SUBJECT: Gear Warning Transition

MODELS/ SN  
AFFECTED: M20V - 33-0002 Only

INTRODUCTION: This Service Bulletin will provide a greater airspeed cushion to the landing gear warning system, and will give an earlier gear warning "in power" to the upper position transition.

Figure SB M20-328-2 - BACK OF INSTRUMENT PANEL

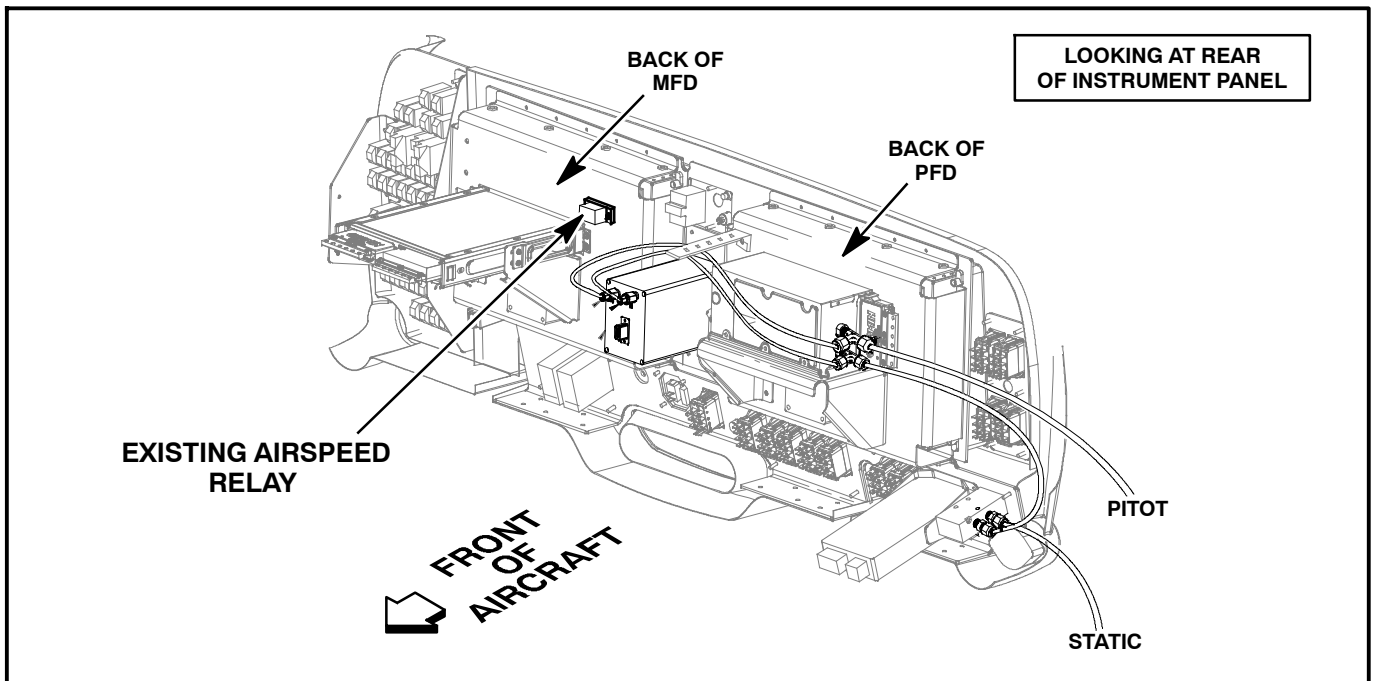
- 1.7. From behind Instrument panel, locate and unmount the existing airspeed relay. Retain hardware for re-assembly refer to Figure M20-328-2.
- 1.8. Looking at front Instrument panel (MFD recess), carefully drill 2 holes (.20" diameter) thru 820367-13 panel parallel to existing nutplates refer to Figure M20-328-3.

Figure SB M20-328-4 - WIRING HARNESS MODIFICATION

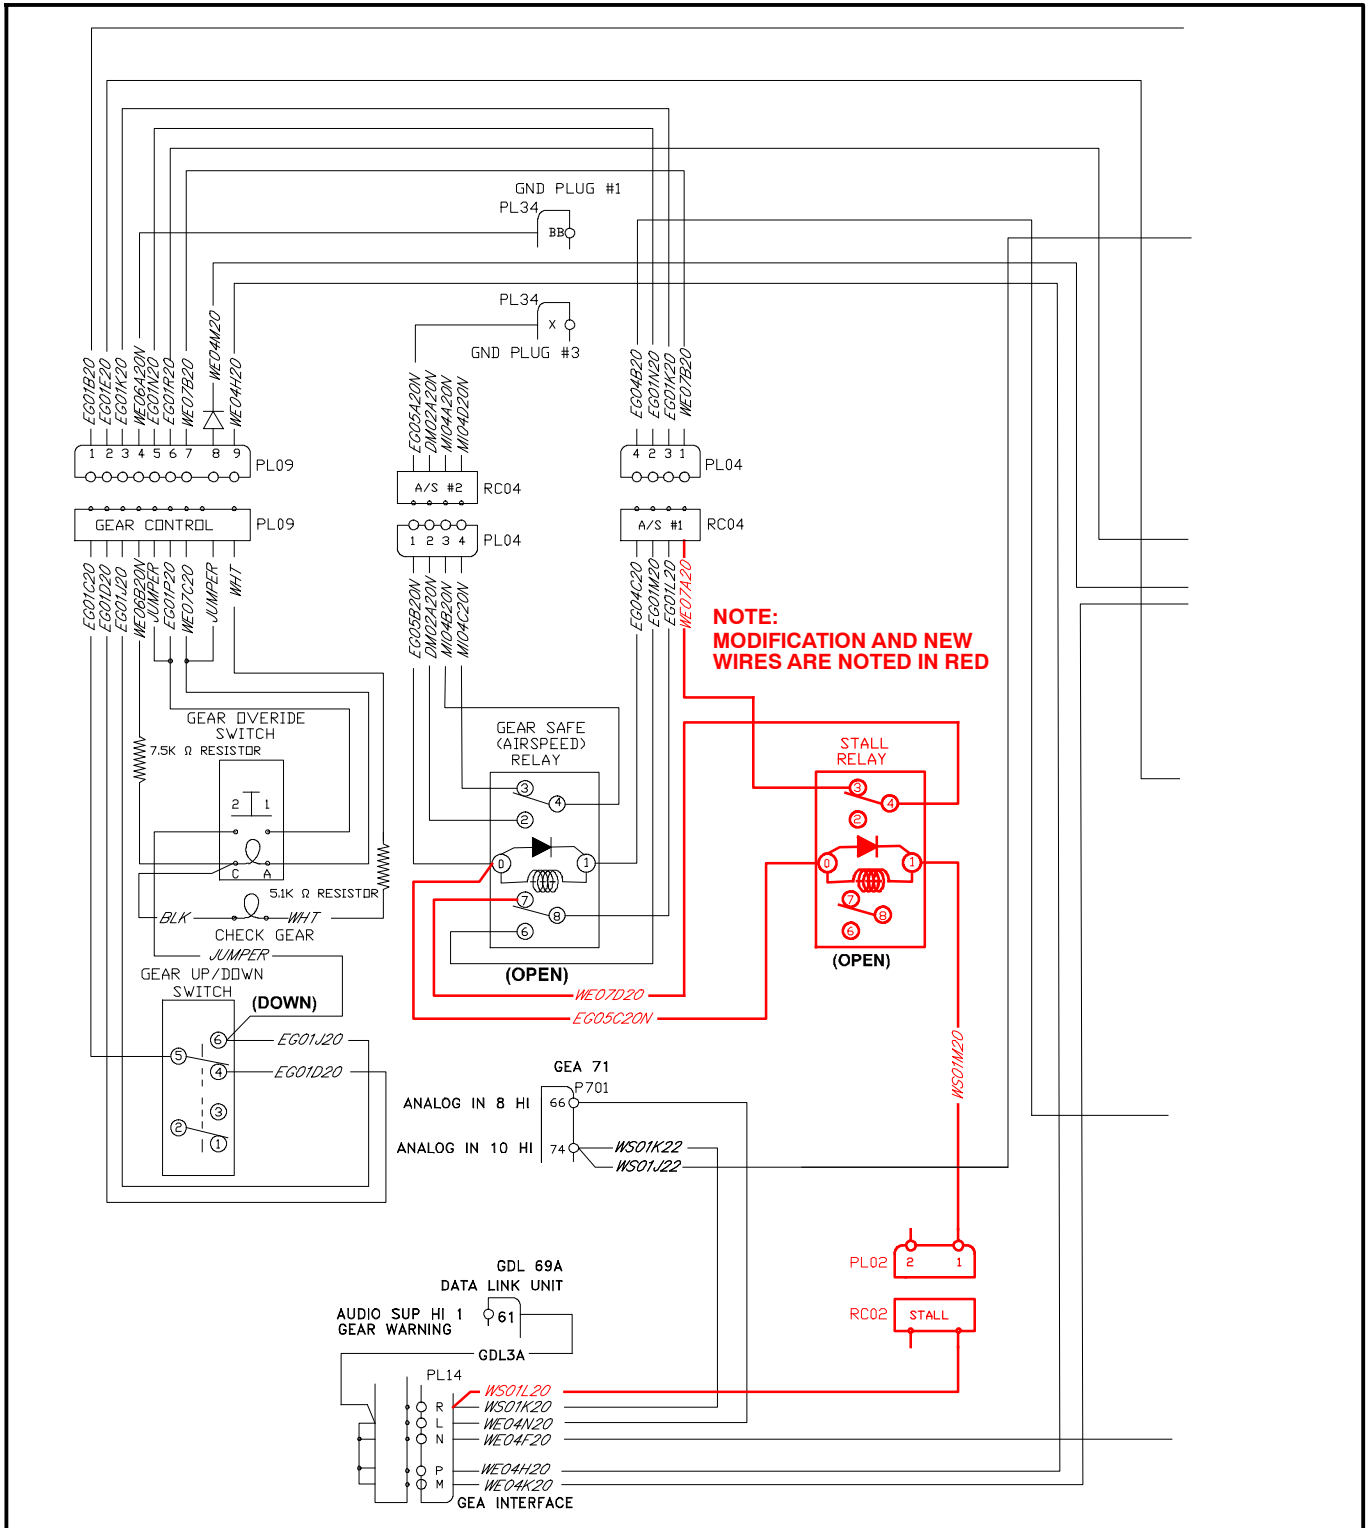
- 1.9. Modify and install new wiring per wiring harness modification drawing Figure M20-328-4. Route wiring along existing airspeed harness, and place new connector at existing A/S1 and A/S2 connector location. All wires/connectors should be installed with heat shrink tubing and cable tie (shop supplied) as required per AC43.13- 2B (or current revision).

Figure SB M20-328-5 - MOUNTING RELAY TO INSTRUMENT PANEL (BACKSIDE)

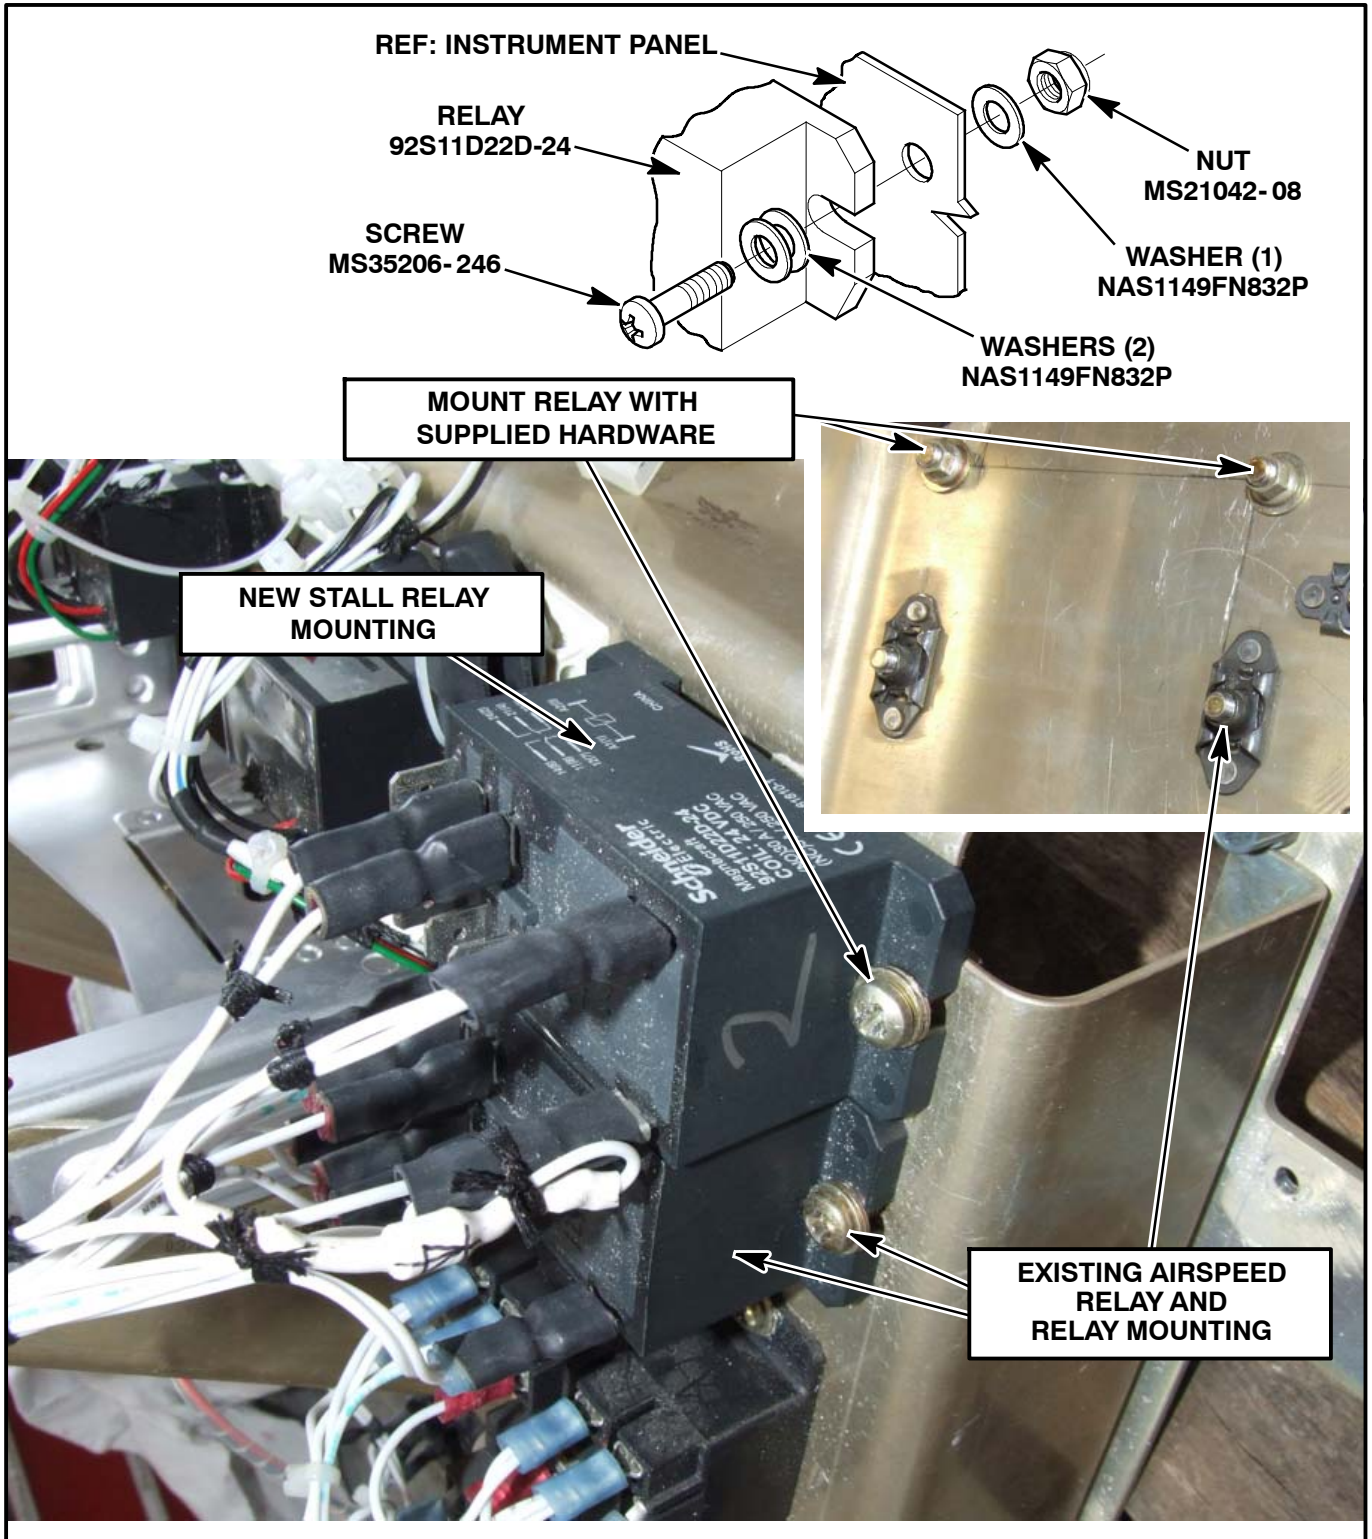
- 1.10. Perform point to point continuity check on newly installed wires. If test does not pass, fix errors and try again.
- 1.11. Once continuity check has been performed and validated good, re-install airspeed relay on back panel with removed hardware, 2 qty MS35206-246 screws, 4 qty NAS1149FN832P washers, in Instrument panel (MFD recess) per Figure M20-328-5.

- 1.12. Install the new stall relay on back panel with 2 qty MS35206-246 screws, 4 qty NAS1149FN832P washers (2 under head of each screw and 1 under nut), 2 qty MS21042-08 nuts in Instrument panel (MFD recess) per Figure M20-328-5.
